September 26, 2000

FROM: William D. Travers */RA/*  
Executive Director for Operations

SUBJECT: FINAL GUIDELINES FOR APPLYING RISK-INFORMED  
DECISIONMAKING IN LICENSE AMENDMENT REVIEWS

### USE OF RISK INFORMATION IN REVIEW OF NON-RISK-INFORMED LICENSE AMENDMENT REQUESTS

**Figure 1 - Process and Logic for Considering Risk in License Amendment Reviews**

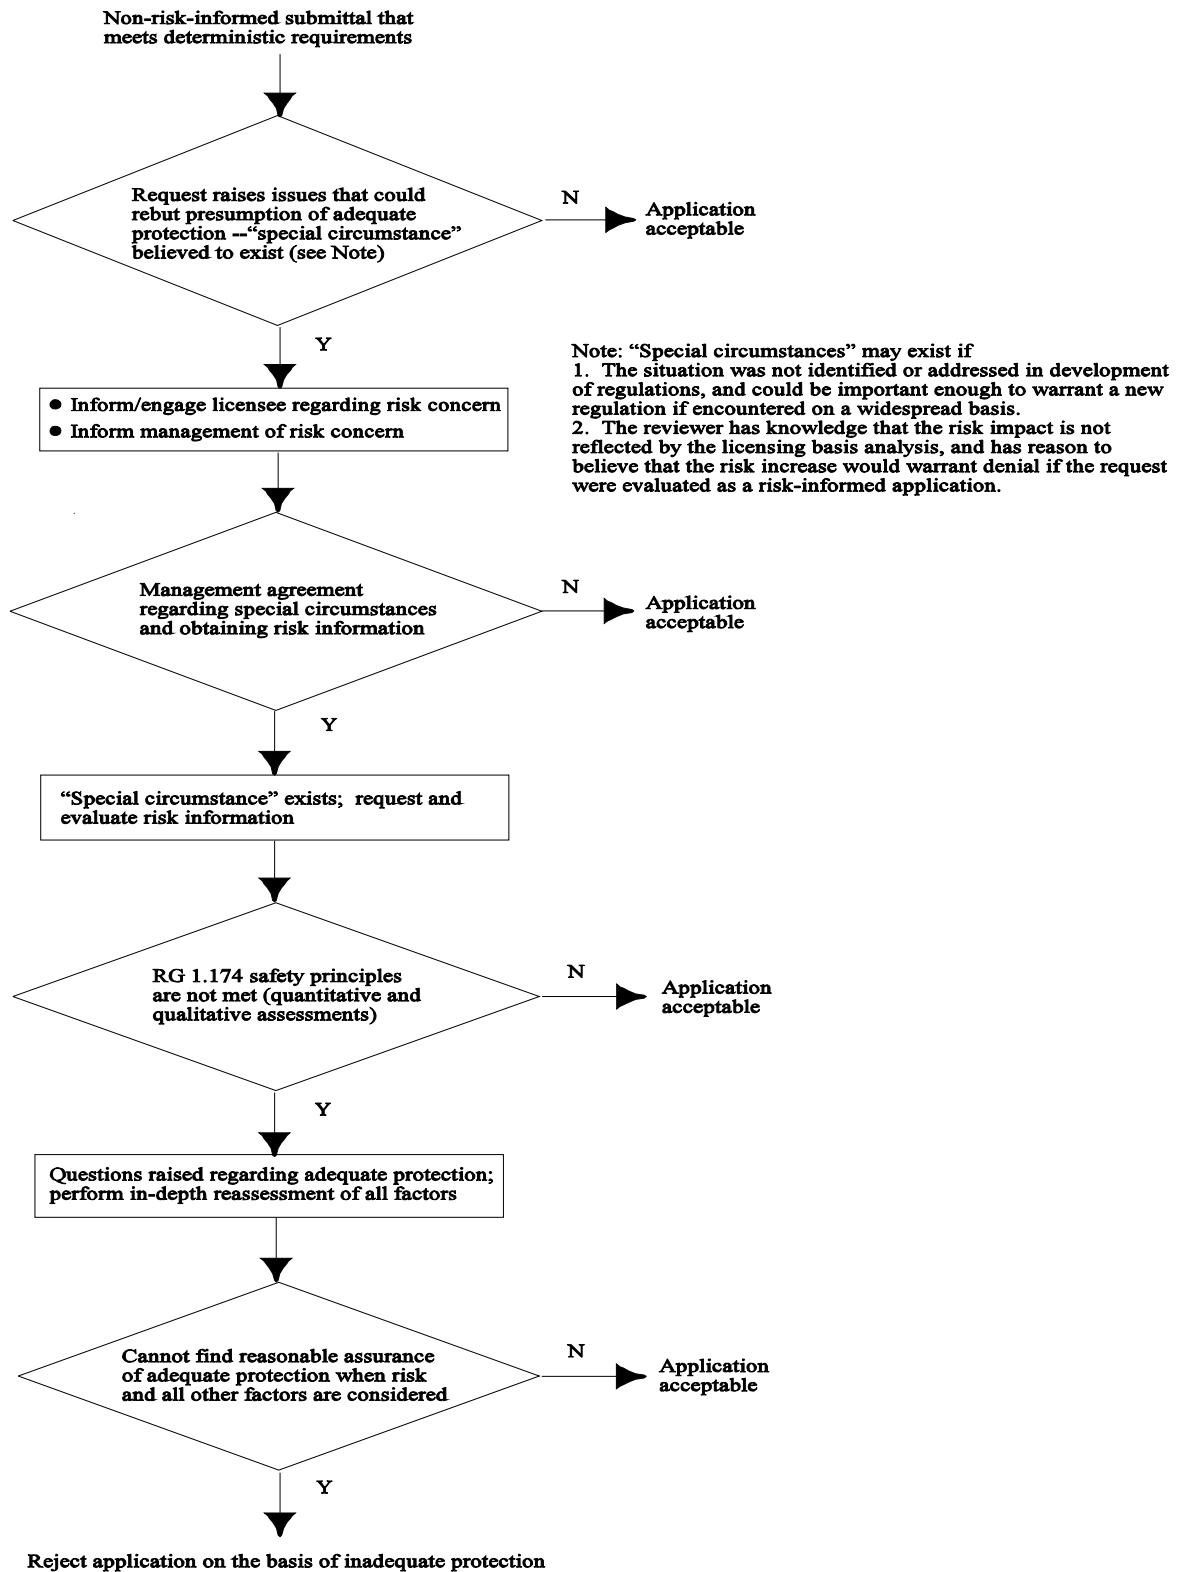
1. Comment: Clarify the flowchart to describe the point at which NRC would notify the licensee of potential risk issues (NEI 2).

2. Comment: Clarify the flowchart to describe the level of NRC management that would determine the existence of “special circumstances” (NEI 2).

11. Comment: The SRP appendix should include the additional wording provided by the NRC staff at the May 11, 2000, meeting of the Advisory Committee on Reactor Safeguards to describe the threshold for determination of special circumstances (NEI 4).

Response: We agree that the guidance should clarify when NRC should notify the licensee of potential risk issues. The text has been modified to indicate that *“The staff should inform and engage the licensee as early as possible in the evaluation process when it believes that a special circumstance may exist, and is considering the need for risk information.”* The flow chart has also been modified to include this step.

Response: The following two criteria cited by NEI for determining whether a special circumstance may exist are already included in the text of the appendix: (1) the situation was not identified or addressed in development of regulations, and could be important enough to warrant a new regulation if encountered on a widespread basis, and (2) the reviewer has knowledge that the risk impact is not reflected by the licensing basis analysis, and reason to believe that the risk increase would warrant denial if the request were evaluated as a risk-informed application. Based on discussions with the ACRS, this language will also be incorporated into Figure 1 of the appendix.
